UNITED STATES PATENT AND TRADEMARK OFFICE

APPLICATION NO.	FILING DATE	FIRST NAMED INVENTOR	ATTORNEY DOCKET NO.	CONFIRMATION NO.
10/731,685	12/09/2003	Marcille F. Ruman	KCX-705 (19342)	3265
22827	7590	07/05/2007		
DORITY & MANNING, P.A. POST OFFICE BOX 1449 GREENVILLE, SC 29602-1449			EXAMINER BOGART, MICHAEL G	
			ART UNIT 3761	PAPER NUMBER
			MAIL DATE 07/05/2007	DELIVERY MODE PAPER

Office Action Summary

DETAILED ACTION

Fig. 2B

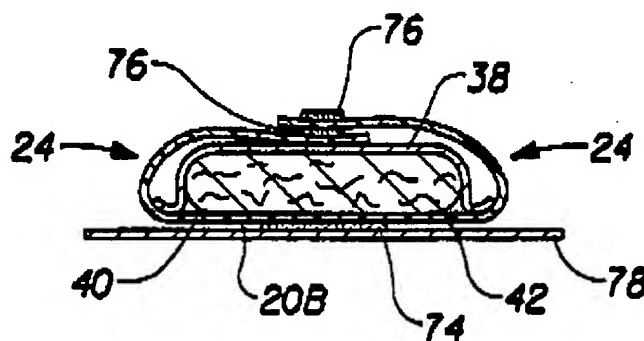
said article (20) and attached backing sheet (78) folded into a configuration such that lateral sides (80D) of said backing sheet (78) are brought together and said backing sheet (78) defines a pouch for said article (20)(see figures 2B, 3 and 4, infra).

Regarding claims 14 and 19, Mills teach that said article (20) further comprises opposite laterally extending wings (24) configured to fold around the crotch portion of a wearer's undergarment, said wings (20) folded onto said top cover (38) in said folded configuration of said article (20) such that garment facing sides (20B) of said wings (24) are outwardly facing (see figure 2B).

Regarding claims 16 and 17, see fig. 2B, *supra*. Mills at col. 6, lines 8-28 incorporates by reference Sneller *et al.* (US 5,308,346 A) which at col. 6, lines 1-22 teaches a backsheet made of nonwoven material which can engage Velcro ® hooks.

Fig. 4

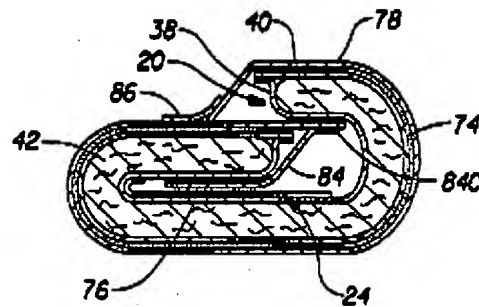
Regarding claims 10, 11, 21, 22 and 25, Mills teaches that outer layer (80) of wrapper (78) is a film that is outwardly facing (see fig. 4, supra). Tameishi teaches that inner layer (81) can comprise a nonwoven adhered (90) to layer (80)(col. 9, lines 19-32).

Regarding claim 3, Mills teaches that top cover (38) comprises a hook compatible material (incorporating by reference at col. 6, lines 9-28, Osborn, III, US 4,950,264, which teaches fibrous topsheets at col. 8, line 57-col. 9, line 44). Mills further teaches that backing sheet (78) prevents attachment of fastener (74) to said top cover (38)(see fig. 4, supra).

Regarding claims 4, 5 and 20, Mills teaches a tri-folded article (20) and backing sheet (78)(see fig. 4, supra).

Regarding claims 6 and 27, Mills teaches a releasable tab (86) that keeps the flap folded (see fig. 4).

Regarding claims 7 and 24, Mills teaches that said lateral sides (80D) of said backing sheet (78) are bonded together to define sealed sides of said pouch (col. 10, line 65-col. 11, line 10)(see fig. 4).

Fig. 2

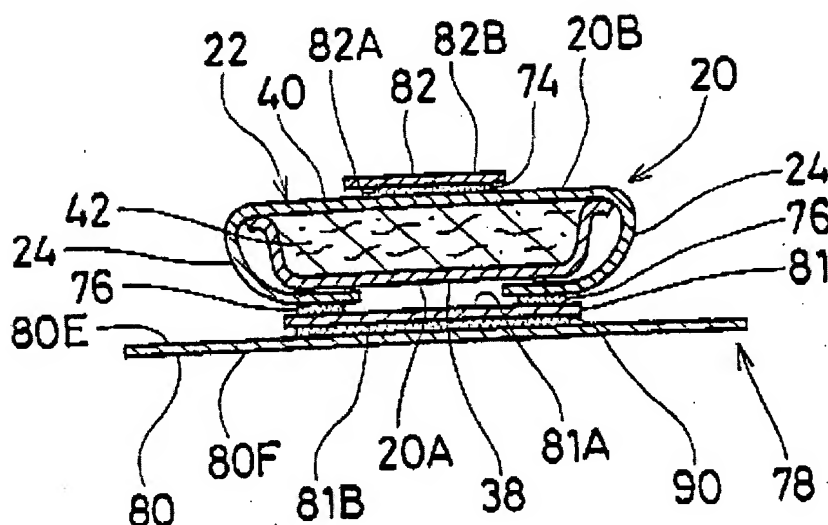
Tameishi teaches an absorbent article (20) in a wrapper (78). Tameishi teaches that the article's impermeable baffle (40) releasably attaches to the wrapper (78) via a Velcro® hook and loop fastener (76)(col. 9, lines 19-32). Tameishi discloses that the wrapper (78) has a nonwoven non-stick face (81A) capable of releasably engaging the Velcro® component, then the Velcro® component on baffle (40) must be a hook component as a loop component could not releasably engage such a nonwoven face (81A)(see fig. 2, *infra*).
